102-07109-MLL/JR  
September 4, 2015

Subject: **Palo Verde Nuclear Generating Station (PVNGS) Unit 2  
Docket No. STN 50-529  
Exigent License Amendment Request to Amend Technical  
Specification Surveillance Requirement 3.1.5.3 for Control  
Element Assembly 88 for the Remainder of Unit 2, Cycle 19**

Subject: **Request to Amend Technical Specification Surveillance Requirement 3.1.5.3 for Control Element Assembly 88 for the Remainder of Unit 2, Cycle 19**

Figure 1 -Before August 27, 2015

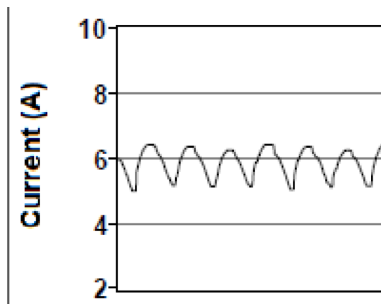
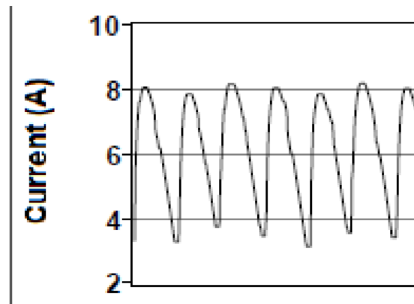
The monitoring results prior to August 27, 2015, reflect a consistent peak-to-peak gripper coil current noise level of 1.4 amps. On August 27, the peak-to-peak current noise level increased to 4.83 amps. This exceeded the monitoring threshold value of 2.5 amps for transferring the holding function of the CEA to the lower gripper coil.

The two following figures show the step change in coil current noise:

Monitoring of the UGC for CEA 88 has indicated an increase in peak-to-peak current noise which is believed to be caused by shorted turns in the coil winding. An open coil condition has not been observed for CEA 88. The possible causes of the shorted turns in the coil winding are:

The increase in UGC current noise between the monitoring periods most likely indicates an initial turn-to-turn short. The turn-to-turn short indicates degraded insulation which is resulting in localized heating. The coil will further degrade with continued use or if energized. The degradation is not linear or predictable. This localized heating can result in further turn-to-turn shorts which will increase current draw until the associated breaker opens, or the coil magnetic holding power is reduced resulting in the CEA dropping into the core.

Administrative controls have been established to only energize the UGC for CEA 88 when necessary for the remainder of Unit 2, Cycle 19. Should an automatic CEA motion demand occur, the UGC for CEA 88 would re-energize and the CEA should move with its group. After movement, the holding function for CEA 88 would be transferred to the lower gripper coil. The UGC for CEA 88 will be replaced in the 2R19 outage, currently scheduled to commence on October 10, 2015.
